CITY OF KINGSTON
REPORT TO COUNCIL

Report No.: 12-134

SUBJECT: Renewable Energy Project – Municipal Consultation Form (MCF)
Kingston Gardiner TS Unity Road Solar Energy Project
2490 Unity Road
File No. PLA-D05-004-2011

Figure 2.1
 Axio Power Canada Inc./SunEdison Canada
 Kingston Gardiner TS Unity Road
 Site Layout Plan

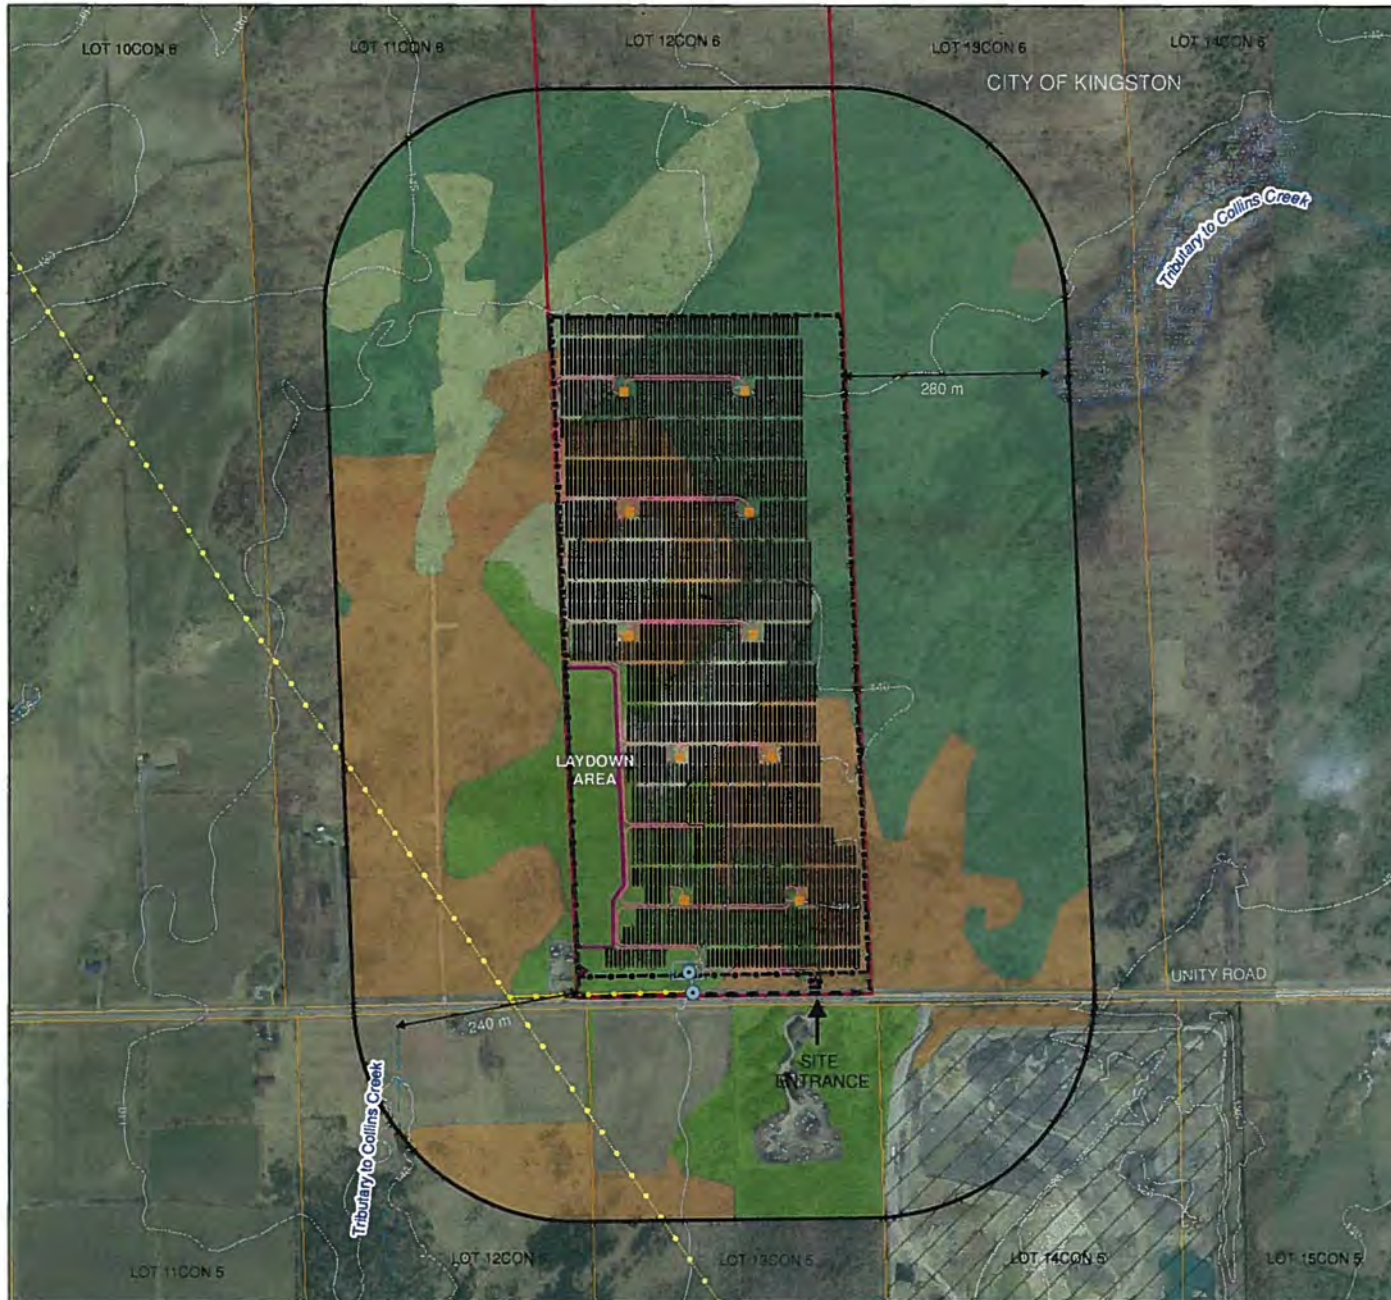
For the stormwater documents, the runoff coefficient used for gravel should be 0.9, and the post-development drawing should show the road-crossing culvert where flows exit the site. Proposed changes to the drainage pattern must not impact the neighbouring properties' drainage. Prior to any on-site works, the proponent will be required to obtain a site alteration permit, and the detailed drawing required for this permit application must illustrate how stormwater runoff will be addressed with the altered property.

The proposed communications tower is to be approximately 25 m (82 ft) high, and according to the Site Layout Plan, is to be located in the southwest corner of the property. This location is adjacent to a 0.5 acre residential property. An alternate location for the tower should be chosen, so that it is not directly next to any residential properties.
